Date: 13th April 2021

Your ref: 15/00314/AOP

Re: South West Milton Keynes, Updated Transport Assessment

Location: Land South Of The A421 West Of Far Bletchley North Of The East West Rail Link And East Of Whaddon Road Newton Longville

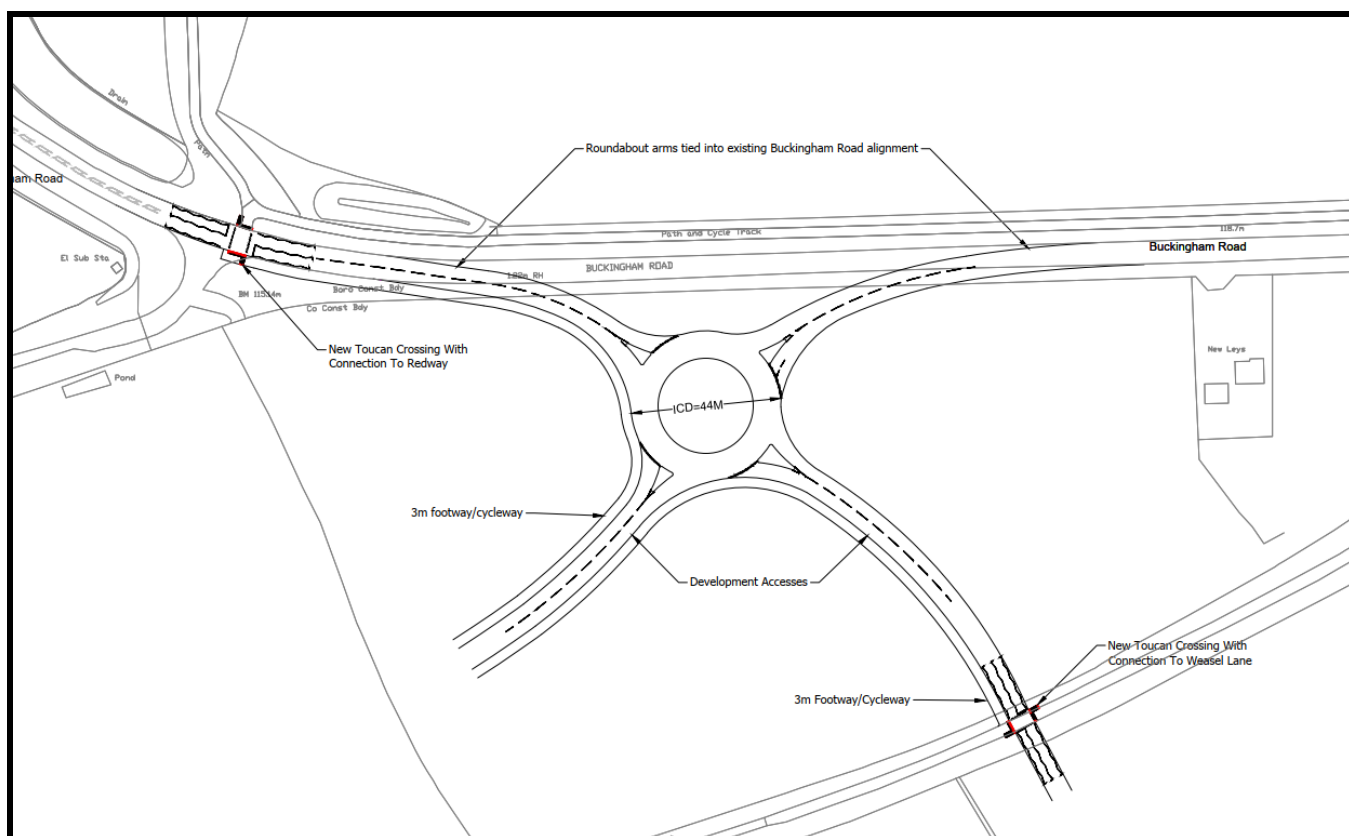
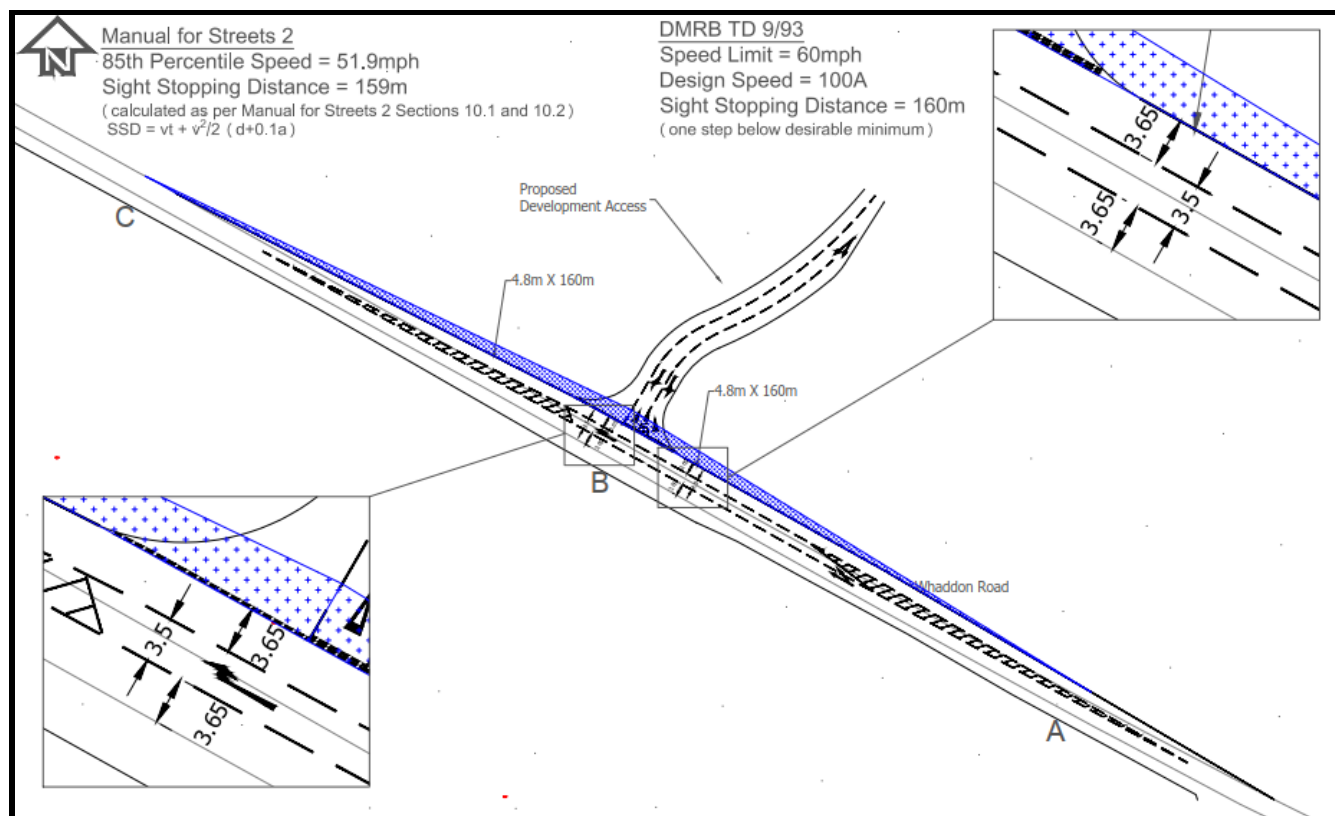
An independent Stage 1 Road Safety Audit has been undertaken and Buckinghamshire Council is satisfied that the problems identified can be resolved during detailed design. The current design as shown in the May 2020 TA shows wide single lane entry approaches on Buckingham Road East, Buckingham Road West and the eastern Site Access. For these arms of the roundabout to work effectively, as modelled, they should be widened to two lane approaches capable of accommodating 2-3 cars. Furthermore, to improve circulation of the roundabout the diameter of the central island should be reduced. This is achievable within the limits of the highway and land within the applicant's control and can be secured by way of a condition revisions were undertaken at the request of BC to provide

minor lane marking improvements, as shown on Drawing 0017D. This version would be required to be taken forward to detailed design.

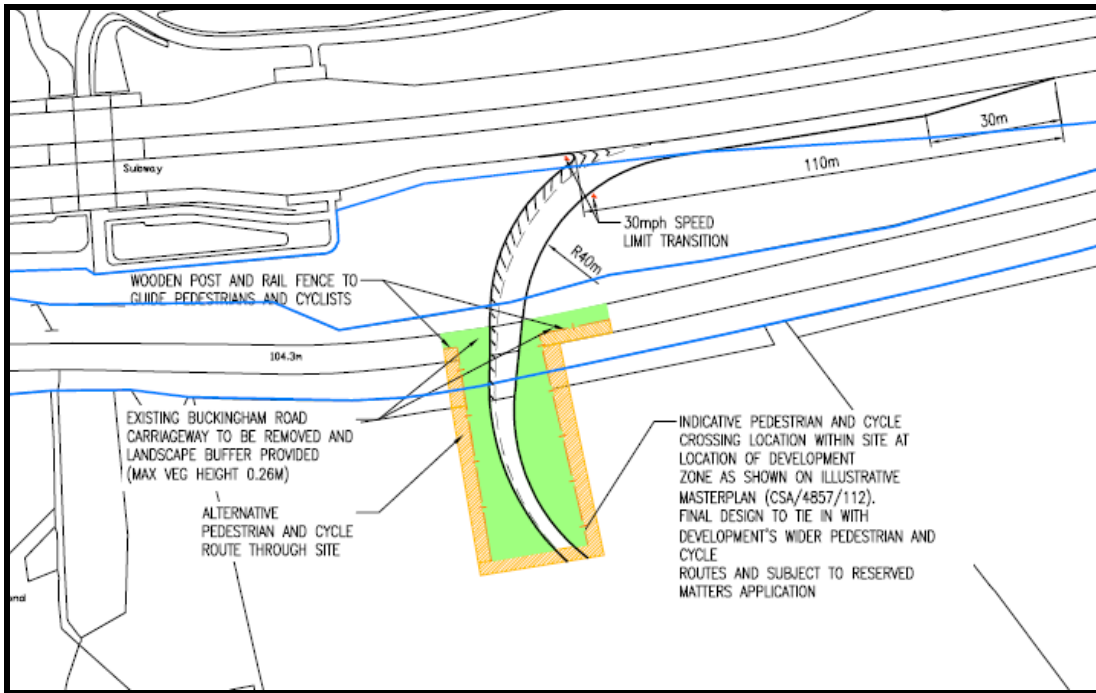
In TRN1 the applicant provided an arrangement to manage the potential interaction with Old Buckingham Road, replicated below. The arrangement would enable pedestrians and cyclists to divert further into the Site and to cross the proposed road access safely. Whilst this design provides a less direct route, it does in principle provide a safer crossing location with lower vehicle speeds. The set-back crossing also reduces the potential environmental impact of tree removal to ensure adequate intervisibility for an in-line crossing, the design of which would be finalised as part of reversed matters.

Based on the new information provided, Buckinghamshire Council does not have any objections in principle to the proposed access arrangement, subject to detailed design and entering into relevant Highways Agreements. This can be secured via means of a S106 obligation.

Junction 3: Bletchley Road/Stoke Road/Drayton Road/Whaddon Road – Mitigation proposal

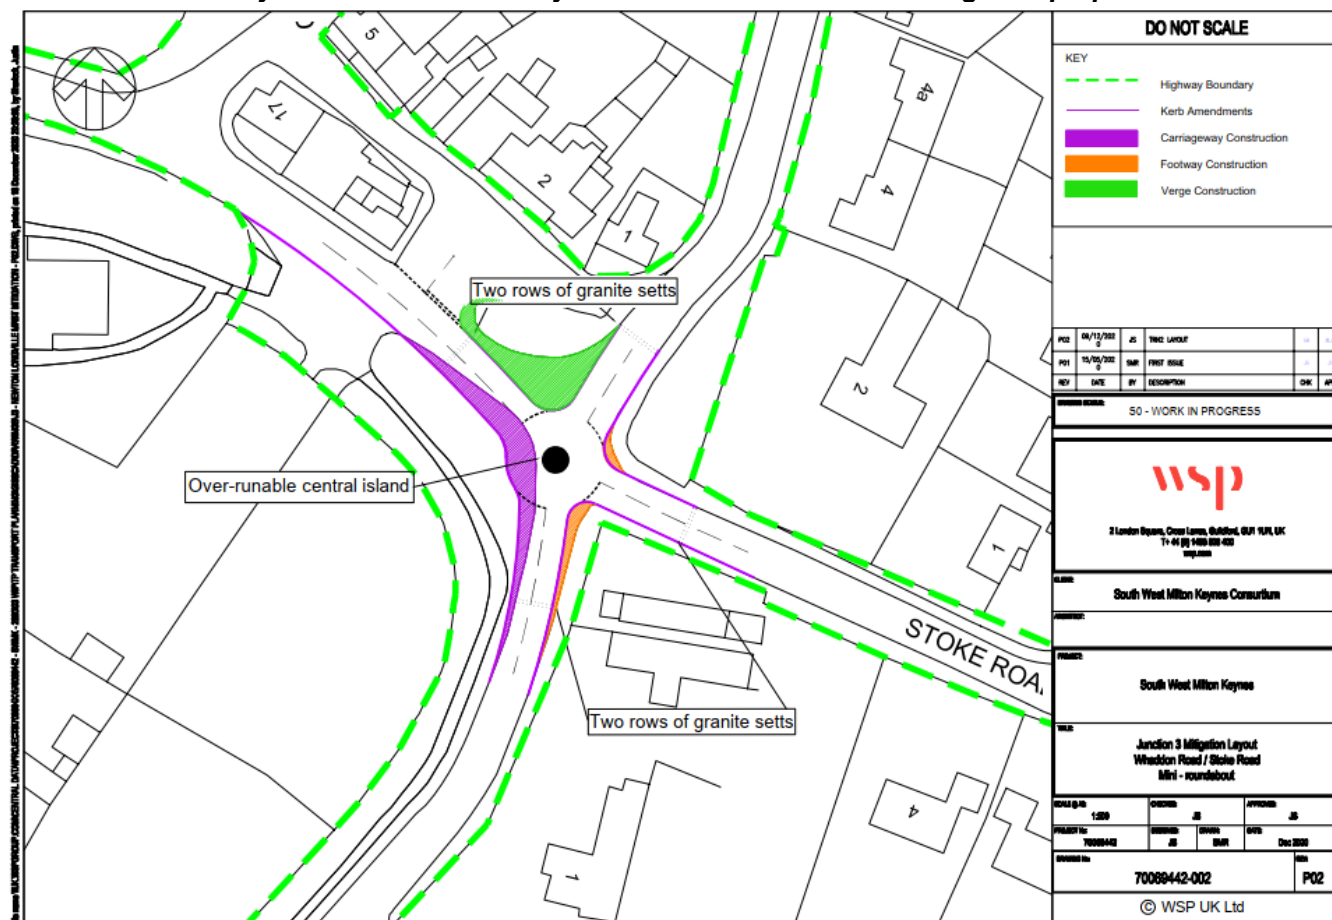
The modelling exercise has shown that the addition of development traffic would have a material impact on the operation of the junction. The Applicant has however proposed changing the form of the junction from a priority crossroads to a mini roundabout, shown below.

The mitigation scheme results indicate the mini-roundabout would operate within practical capacity (RFC of 0.85) for all DS scenarios with a maximum queue of 3 vehicles and delay 20 seconds on Stoke Road. Whilst the change in junction form would improve the capacity, operational road safety concerns were raised within the Road Safety Audit in relation to operation, lack of deflection (due to land constraints) and achievable visibility due to adjacent property lines. Initial indications on review of the mini-roundabout design against 'CD116 Geometric design of roundabouts' showed less than desirable visibility to the right on Drayton Road and stopping sight distance on three of the arms. Paragraph 2.12.1 of CD116 also states that a 4-arm mini-roundabout should not be used where the sum of the

On this basis, the Highway Authority recommends that the junction is retained as a priority crossroads. A new raised junction table should be provided, as part of a comprehensive traffic calming scheme for Newton Longville. This would act to slow vehicle approach speeds to the junction and make the junction more visible to drivers. The cost of providing a raised table in this location has been included in the proposed traffic calming contribution, set out later in this response.

Junction 7: A421/Coddimoor Lane/Whaddon Road – Mitigation proposal

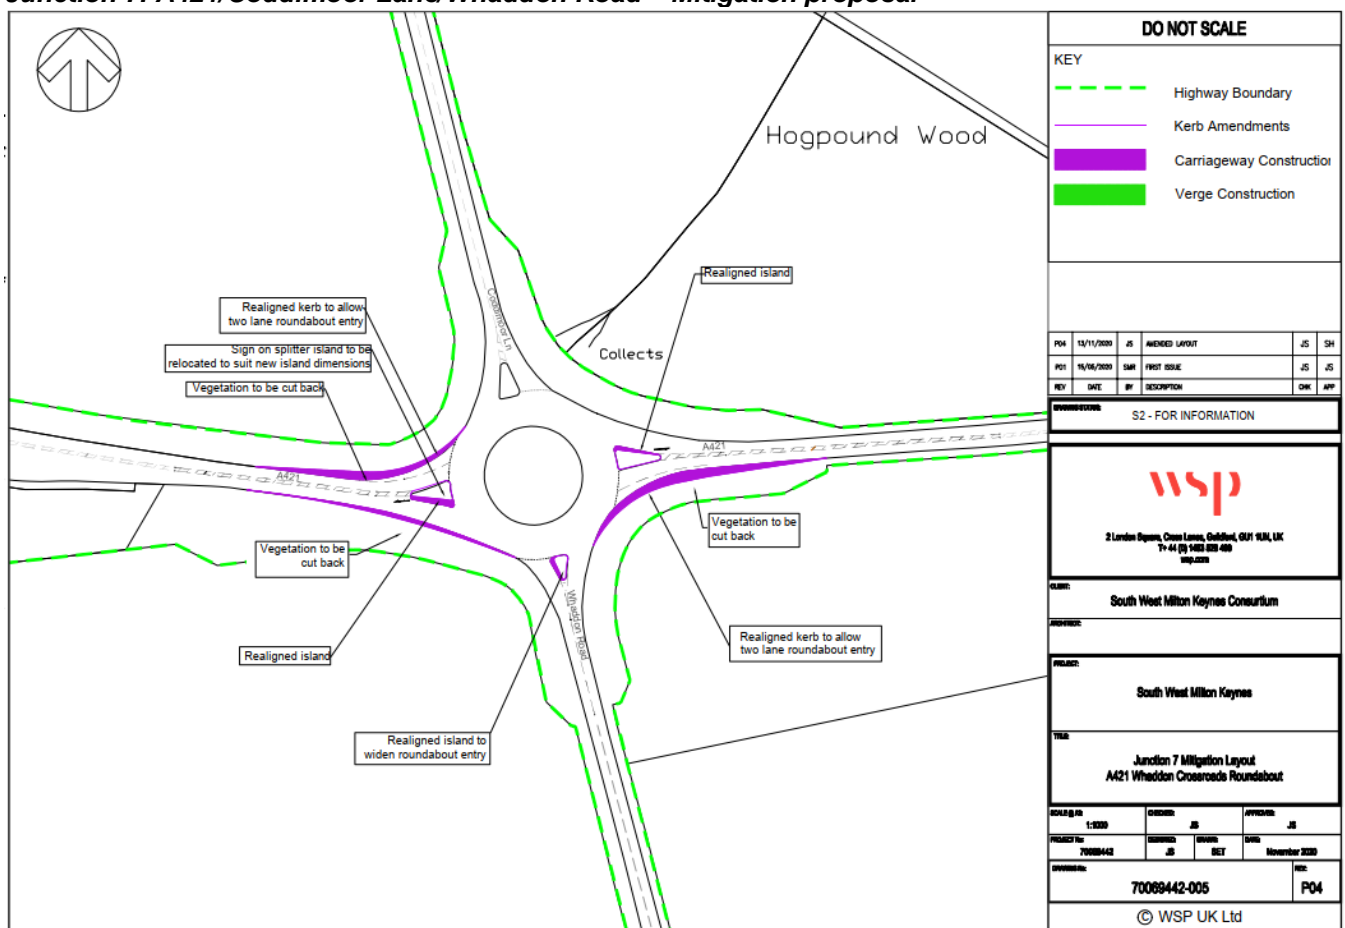
The Applicant has proposed alterations to the current layout to improve capacity, this involves realignment of the kerbs on the approaches from the A421 (east) and A421 (west) with associated amendments to the kerb/islands allowing for two lane roundabout entry and short two lane exit. Whaddon Road entry would also be widened with a reduction in the traffic island size. Due to the minor kerb line amended the previously determined capacity corrections were maintained.

The modelling results show that the proposed mitigation package will reduce queueing and delay on the A421 and Whaddon Road arms of the junction below the levels identified in the 2033 Do Nothing Scenario. There will be small increases in queueing and delay on the Coddimoor Lane arm, but these are negligible with predicted queues still less than one and maximum delay of less than 20 seconds.

The proposed improvement to this junction should provide a 'nil-detriment' situation, whereby the highway network is 'no worse off' with the proposed development in a future forecast year of 2033. This goes beyond the requirements of the NPPF and therefore is considered acceptable by the Highway Authority. This improvement can be delivered by S278 highways agreement, which is to be secured by way of a S106 obligation.

Junction 8: A421/Warren Road – Mitigation proposal

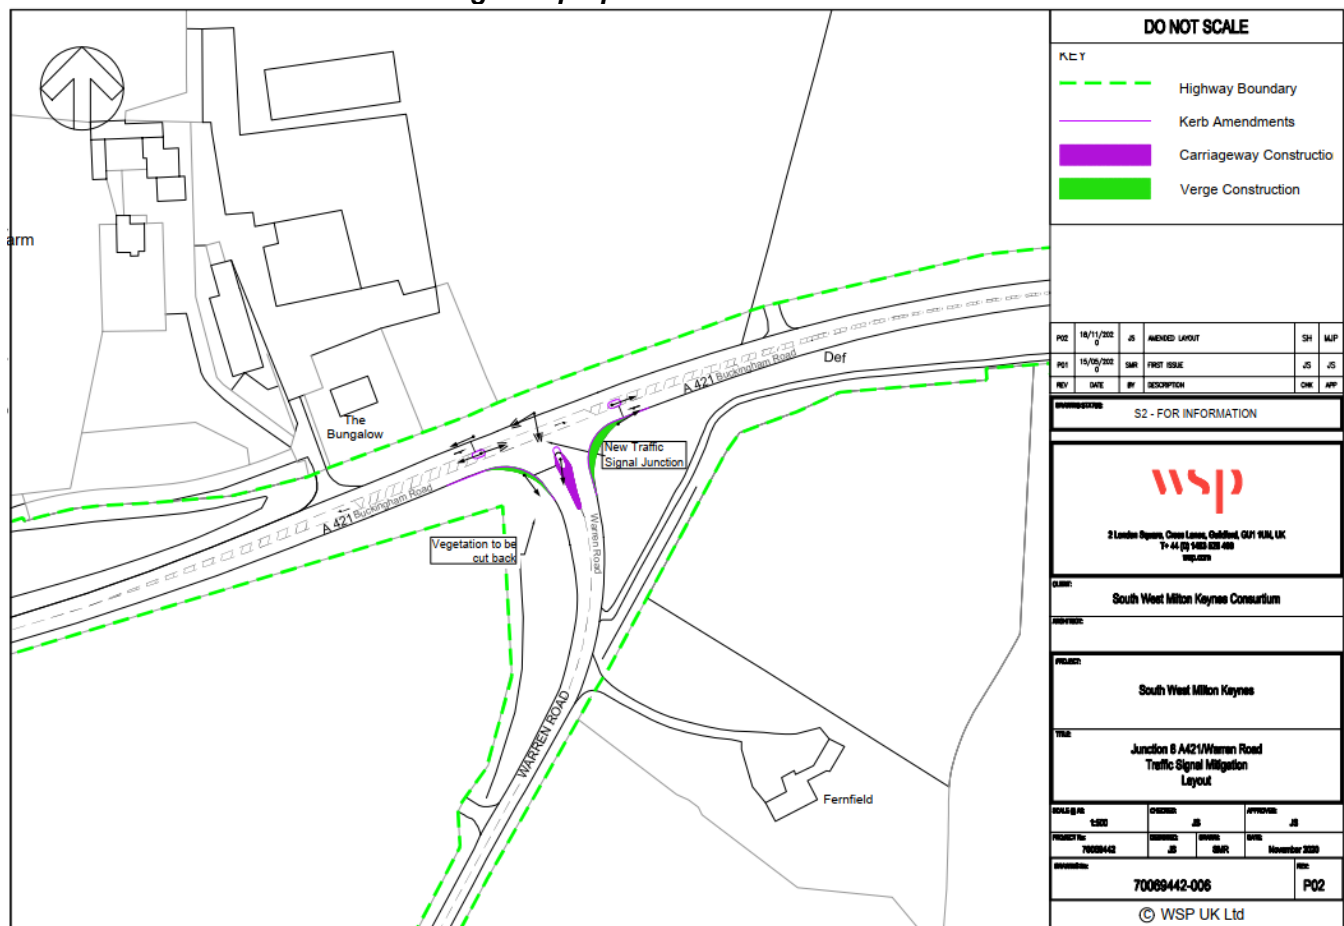
The development is only likely to result in a marginal increase in queuing and delay on Warren Road. In reality drivers would look for alternative routes to the A421. The static junction model does not consider re-assignment of traffic, which would be likely to take place. Whilst the development only results in a marginal increase in queuing at this junction, the applicant has proposed a mitigation scheme to increase capacity through signalisation of the junction.

The proposed improvement to the A421/ Warren Road junction has been modelled using LinSig3 and the results indicate significant benefits in terms of queueing and delay on Warren Road in all the modelled scenarios, with the DS3 (including both SWMK and projected Shenley Park development traffic) have predicted queues and delay less than current 2020 results. However, the signalisation of the junction would impose queues and delay on the A421 corridor.

The cumulative residual impact of the development at this junction cannot be considered 'severe' in the context of paragraph 109 of the NPPF based on the mitigation scheme results. At present the A421 is free flowing along most of its length in Buckinghamshire, with junctions managed through priority junctions or roundabouts. Whilst the introduction of signals would significantly reduce queuing on Warren Road, it would also stop the free flow and introduce delays to the primary route and potentially provide a stop / start scenario. In this regard the principle of commuting an equivalent construction cost of the proposed junction improvement into a Section 106 contribution for A421 corridor improvements between the site and Buckingham is preferable, as set out later in this response.

Junction 9: A421/Shucklow Hill/Little Horwood Road – Mitigation proposal

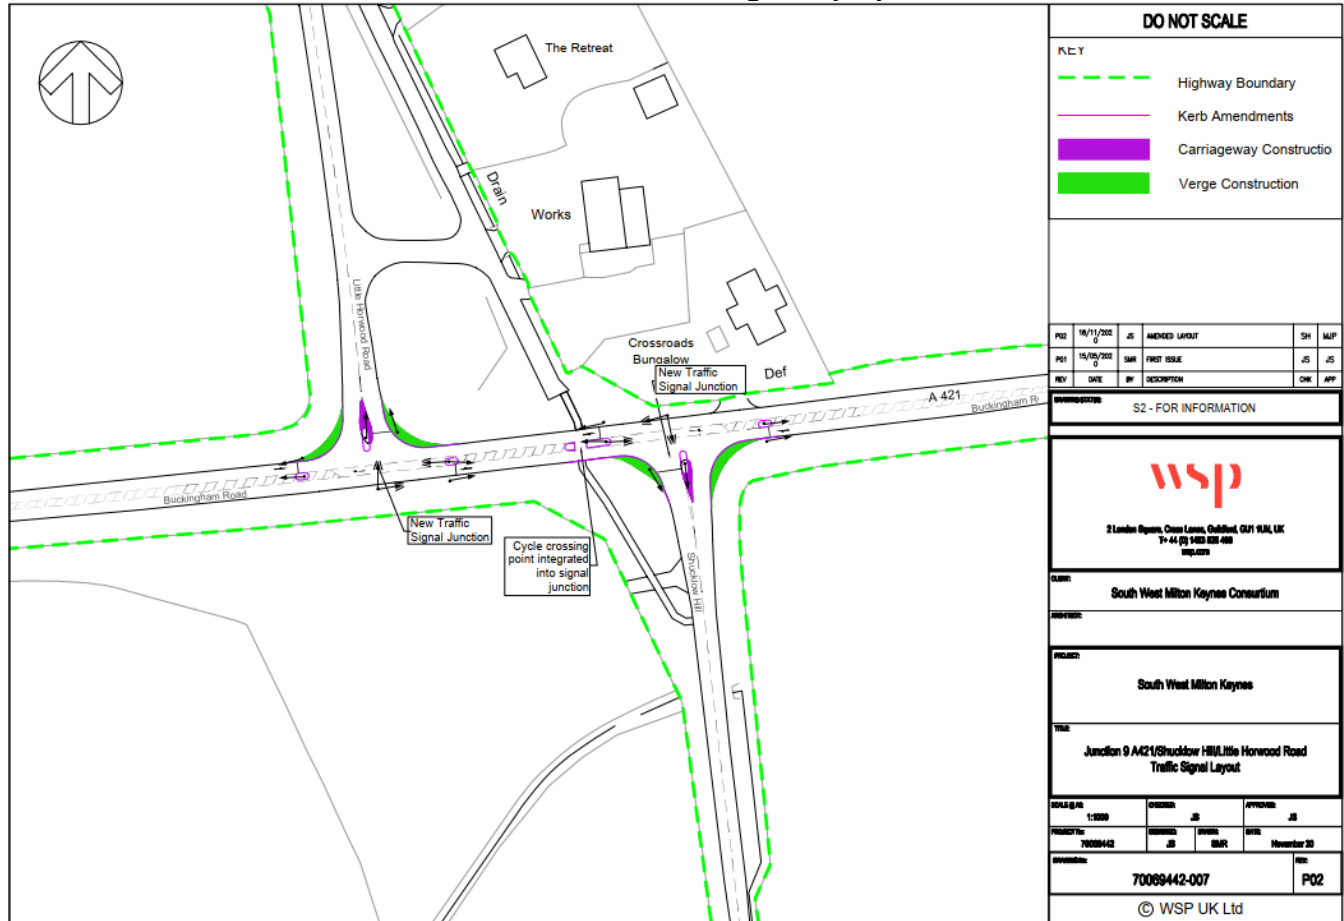
The development is only likely to result in a marginal increase in queuing and delay on Shucklow Hill/Little Horwood Road. Due to the likely capacity restriction on the minor road's drivers would in reality look for alternative routes to the A421. The static junction model does not consider re-assignment of traffic, which would be likely to take place. Despite this, the Applicant has proposed a mitigation scheme to increase capacity through signalisation of the junction.

The proposed improvement to the A421/ Warren Road junction has been modelled using LinSig3 and the results indicate significant benefits in terms of queueing and delay on Shucklow Hill and Little Horwood Road in all the modelled scenarios. However, the signalisation of the junction would impose queues and delay on the A421 corridor with a queue of 24 predicted for the western arm of the Little Horwood side of the staggered crossroads.

Junction 10: A421/Nash Road/Winslow Road – Mitigation proposal

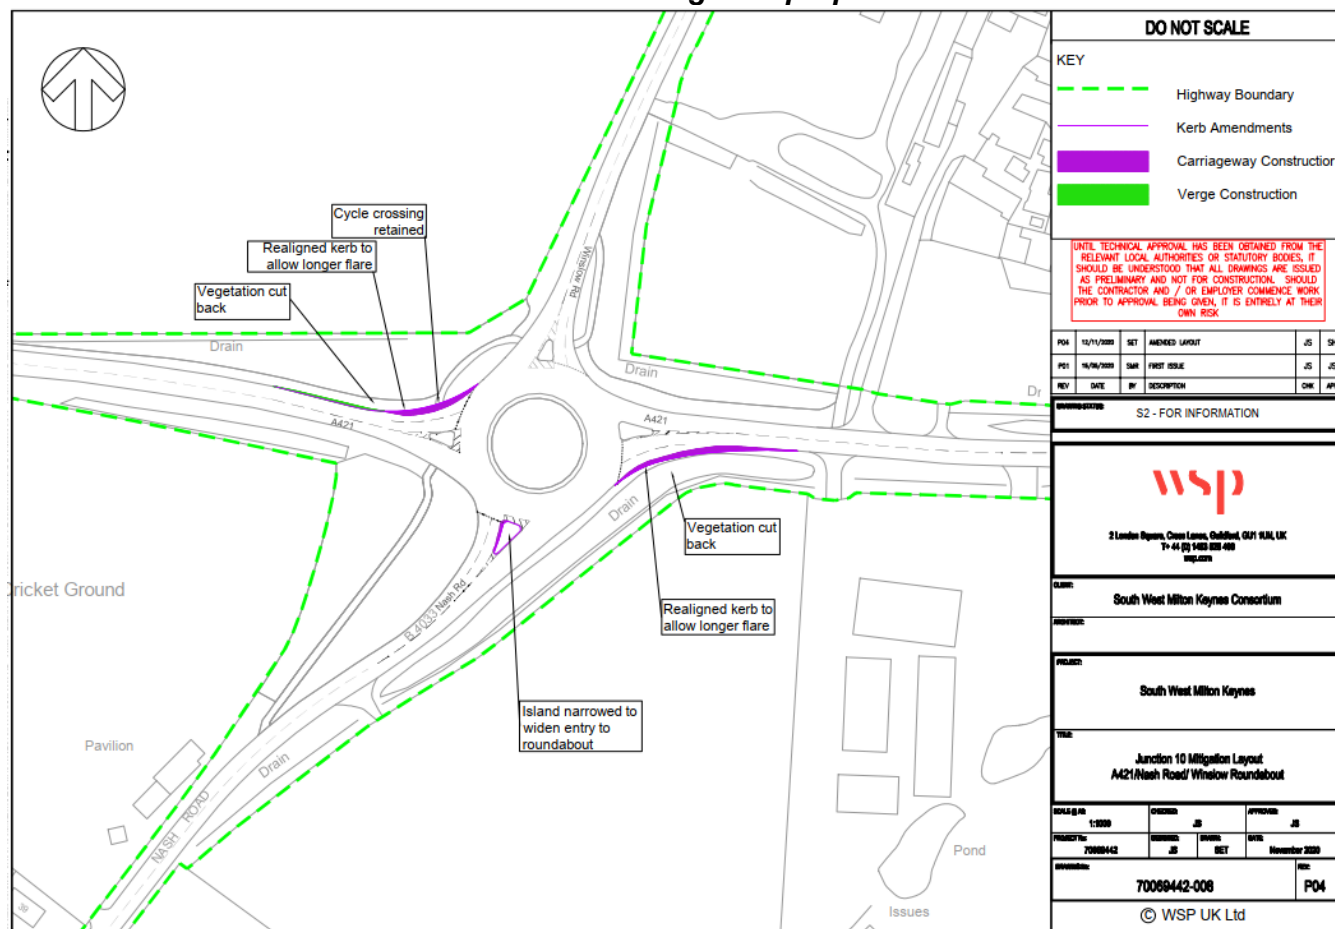
The predicted decrease in capacity due to development, along with the Shenley Park development on the A421 arms may not be considered severe in context of the NPPF. However, the Applicant has submitted a mitigation scheme, in recognition that the junction is operating close to theoretical capacity on the A421 eastern arm and now exceeds this on Nash Road in the PM. This includes realignment to the kerb on the A421 (East) and (West) arms to allow for a longer entry flare to the roundabout, with some minor amendments to the traffic island on Nash Road.

The proposed improvement to the A421/Nash Road/Winslow Road junction has been modelled using Junctions 9 (ARCADY) with the results detailed below.
